S A N G I O L O A S S O C I A T E S A R C H I T E C T S

Application #: 27.0068 AB

Property: 1954 Commonwealth Avenue

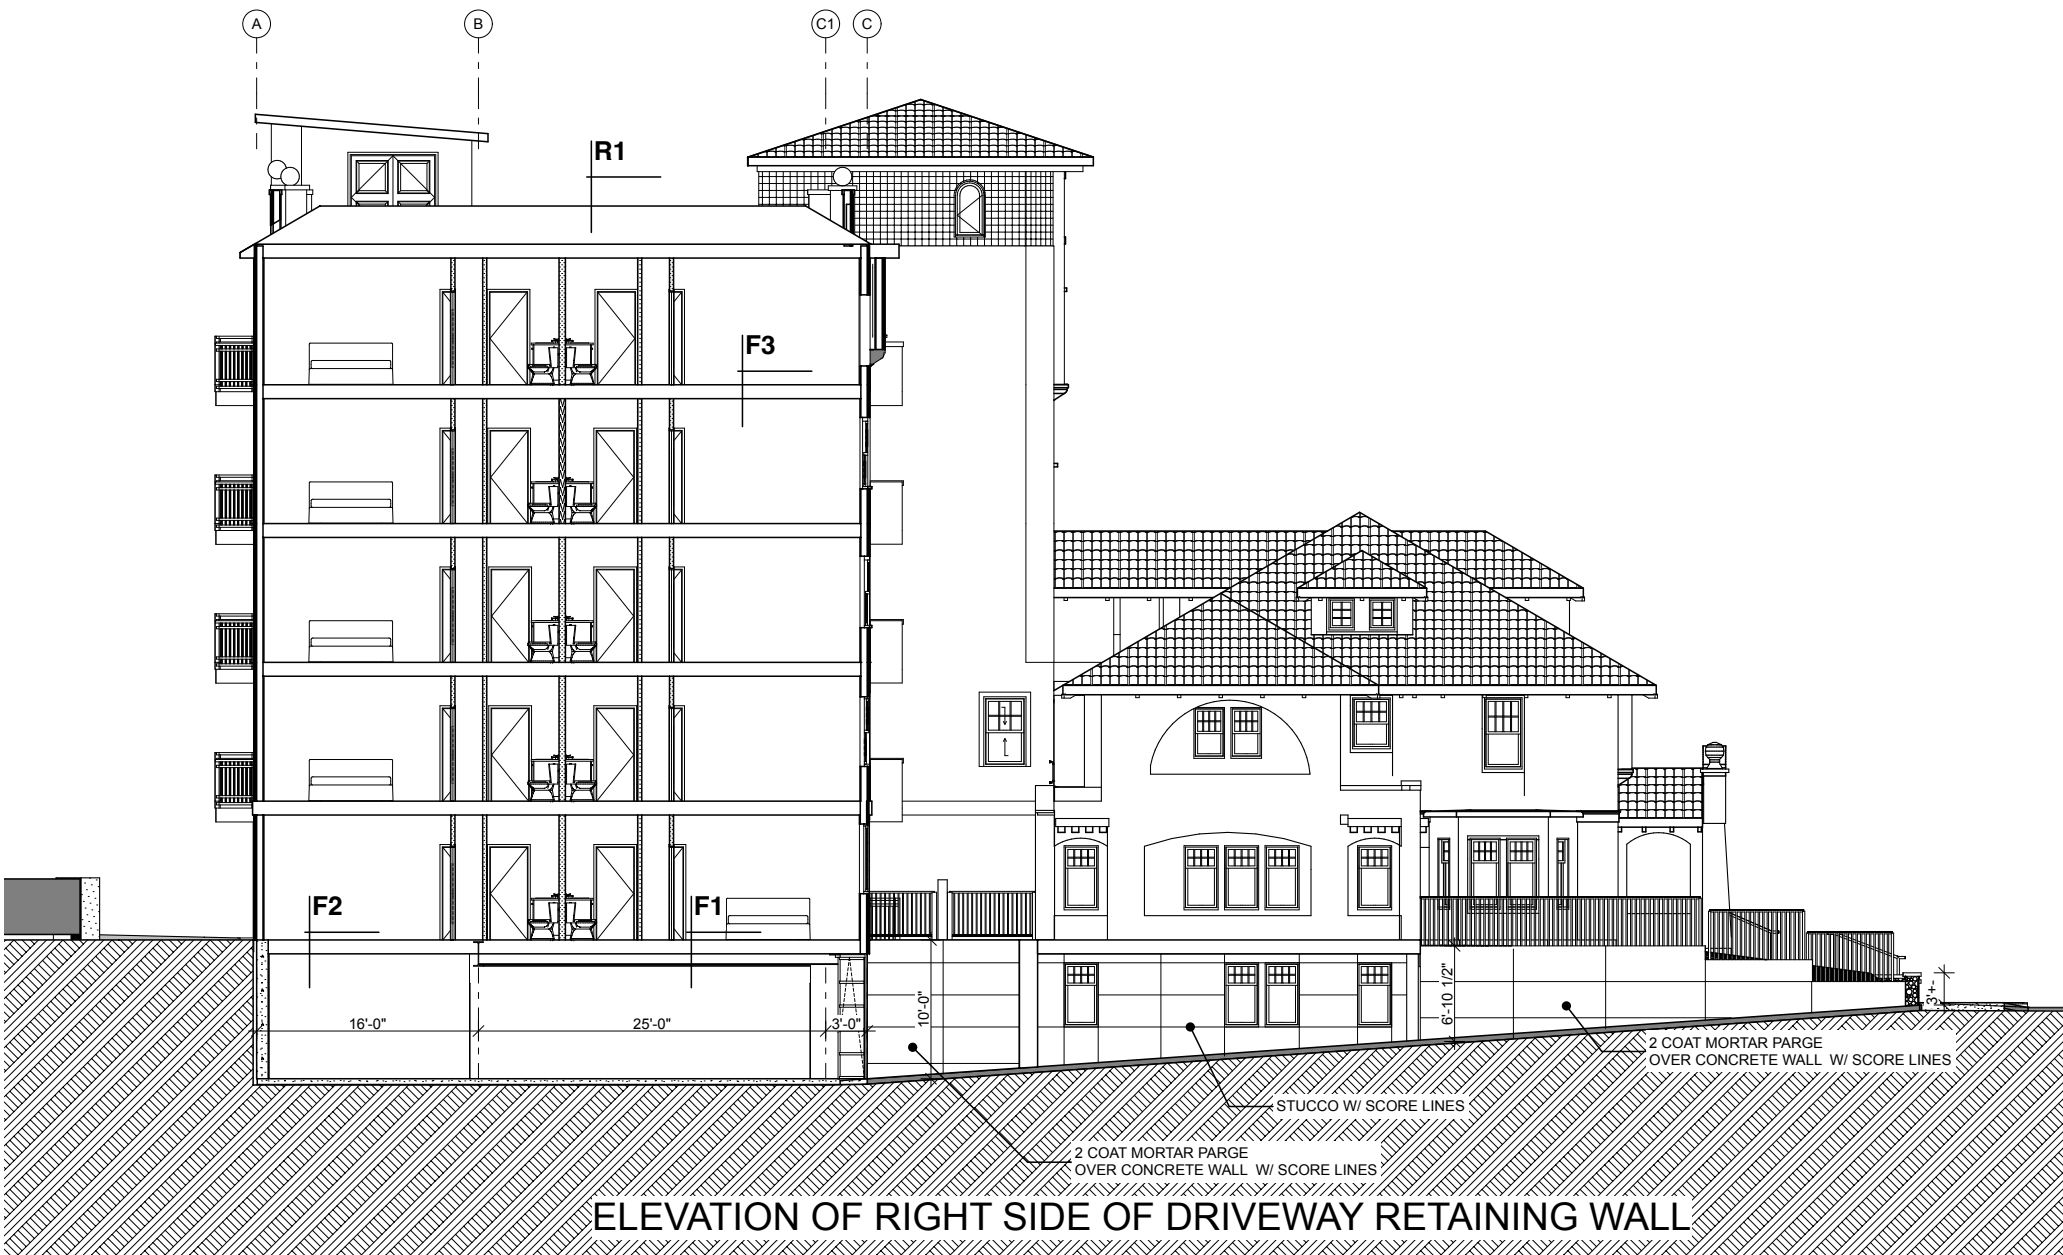
We would like to request an Alteration to the Aberdeen Architectural Conservation District Approval for the project at 1954 Commonwealth Avenue, Brighton MA. We would like to request that the driveway retaining wall material be changed to a concrete wall that would be parged with mortar or stucco with score lines material rather than the approved river rock material that would match the existing 2' high retaining wall along Commonwealth Ave.

The driveway to the garage under the new building has an approximately 7% slope. The wall at the garage entrance will be approximately 12' high. We feel like the scale of the stone in the existing front retaining wall is too small for a wall this size and the cost of a stone wall to the garage would be prohibitive.

We met several times with the BPDA had extensive conversations regarding the material to be used on these walls. It was agreed that a simple mortar parged/stucco finish to match the building would be best.

In our June 9, 2026, Advisory Review Meeting and then again in the July 13, 2026, meeting we presented drawings and discussion that stated that we walls would be concrete with mortar/stucco, we never intended for the wall to be stone or stone veneer.

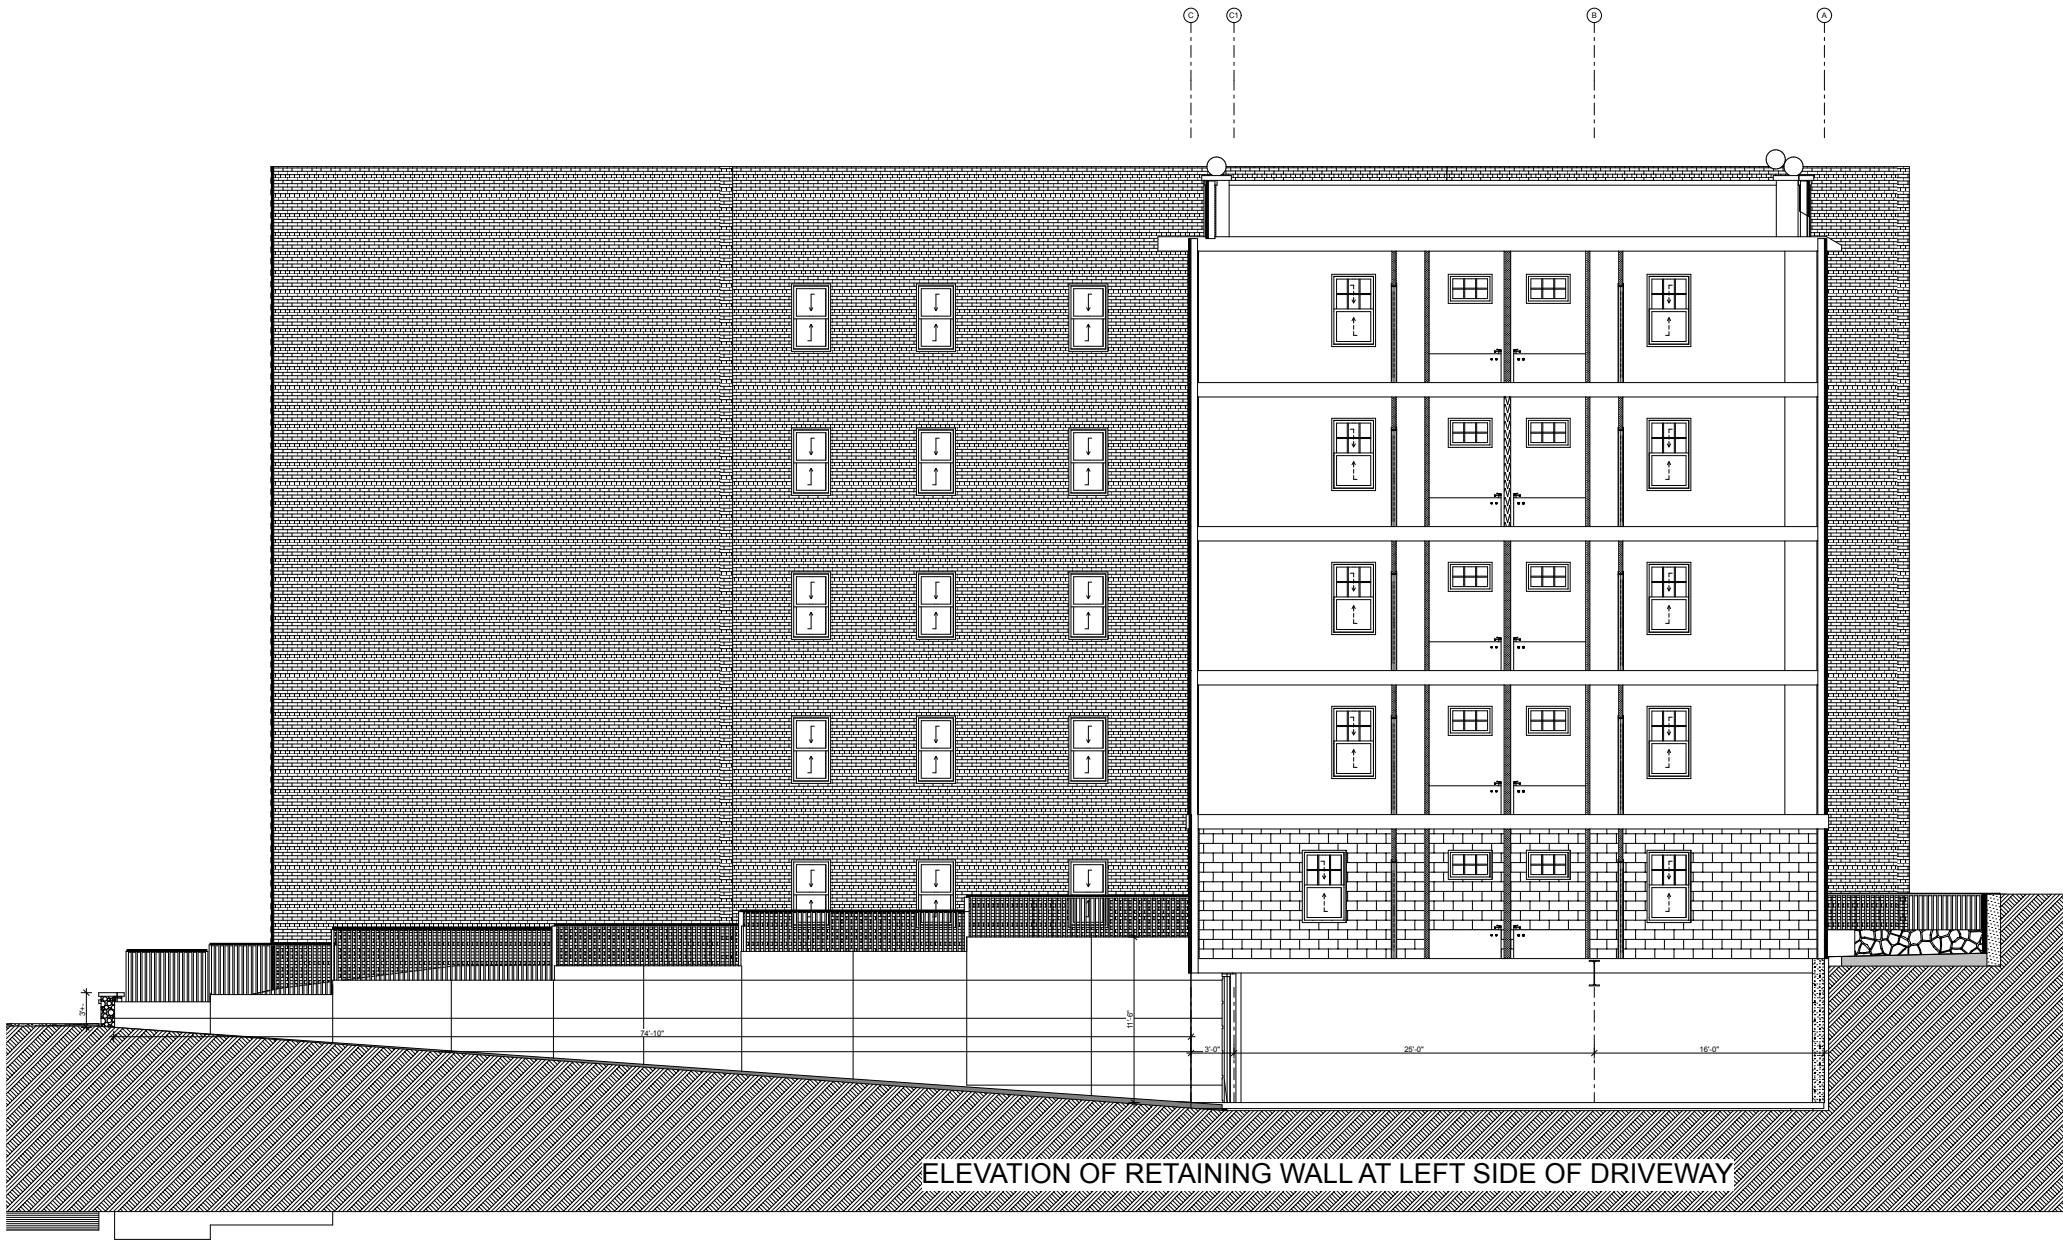
If you would like we could introduce stone piers on either side of the new driveway entrance, like the piers on either side of the existing front walkway, to punctuate the transition to a different wall material in the driveway. Please see the attached drawings and images of the existing stone wall along Commonwealth Avenue.
